SERVICE *No. 246* BULLETIN

Subject: Modification of Oxygen Cylinder Rear Retaining Strap
Piper Part Number 758 109

Models Affected: PA-30 Twin Comanches (NOTE: Applicable only to
aircraft that have had an oxygen system installed at
the factory or aircraft that have had Piper Oxygen
Installation Kit 757 100 installed.)

246f1

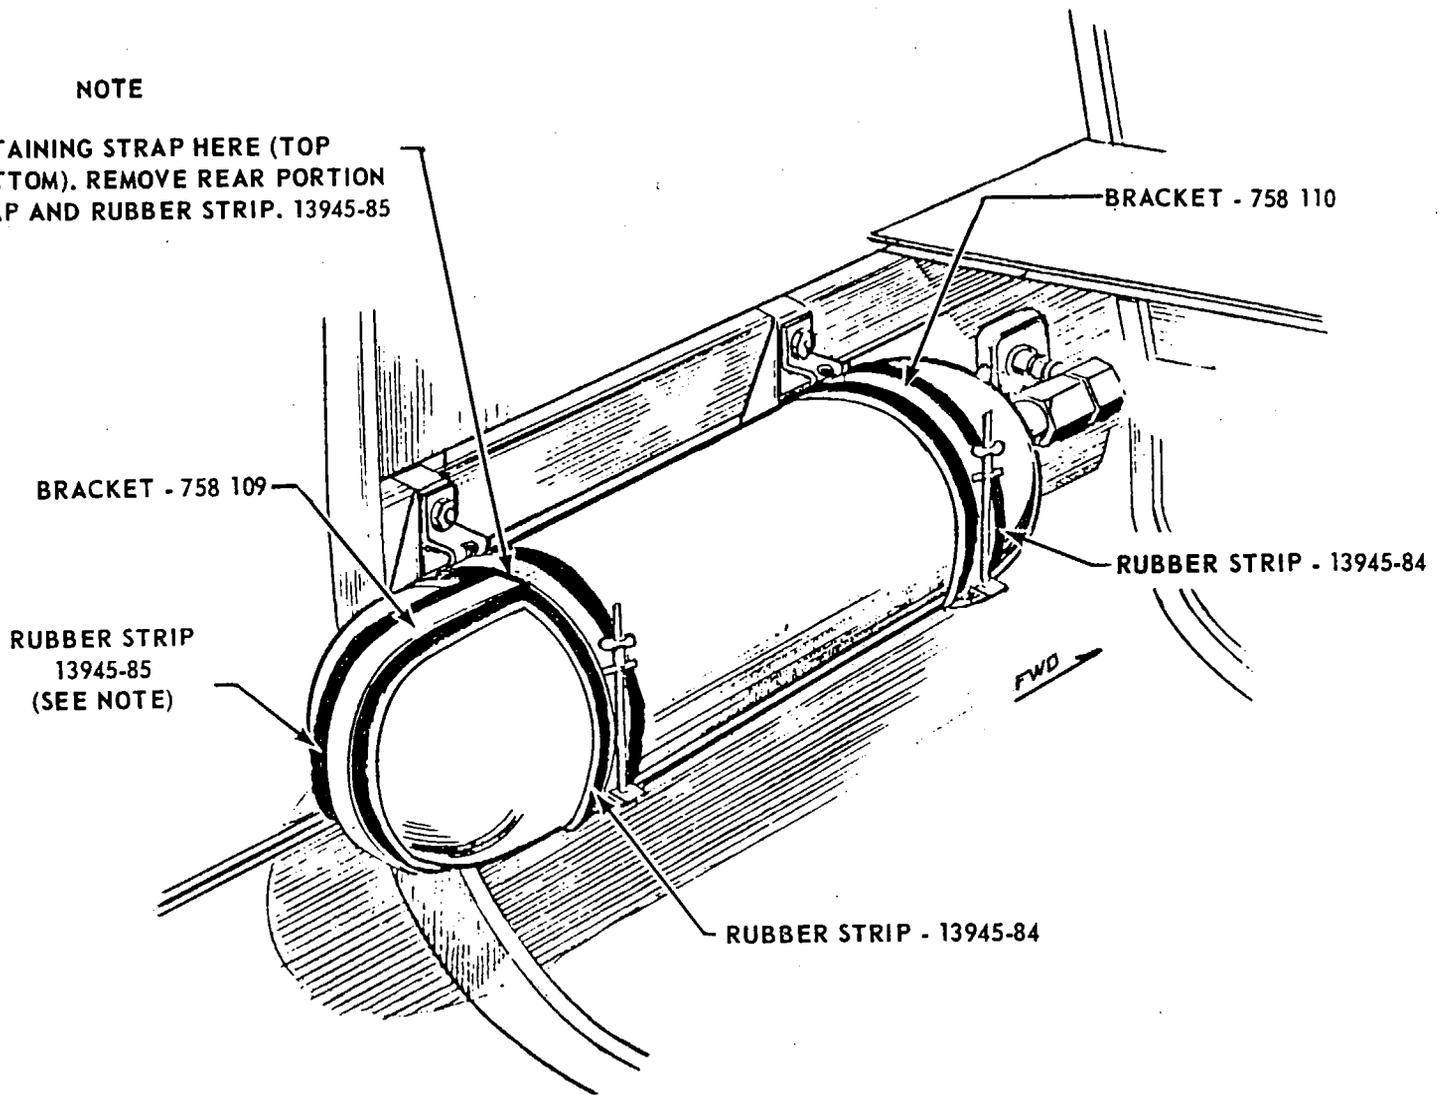
Reason For Bulletin: Modification of the oxygen cylinder rear retaining strap
part number 758 109 to preclude the possibility of the
strap rubbing the rudder control cable.

Modification Instructions: See sketch on reverse side of this bulletin.

RETAINING STRAP HERE (TOP AND BOTTOM). REMOVE REAR PORTION STRAP AND RUBBER STRIP. 13945-85
